Reviewer 2

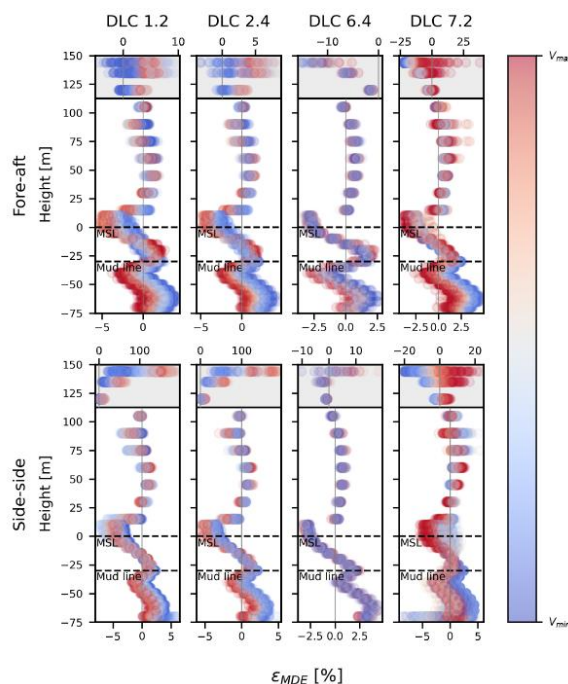
RC2.23) (Figure 14) As per the introduction of the paper, the levels below MSL might be the ones with difficult accessibility and thus the ones where MDE might be more useful. However, in this figure, the large error at TT cloud the understanding of the errors at lower levels. Would it make sense to split the figure to allow two x-axes?

RC2.23) Thank you for bringing this to our attention. It is indeed difficult to assess the errors at lower levels, and a good idea to split the figure. The figure has been corrected according to this comment as:
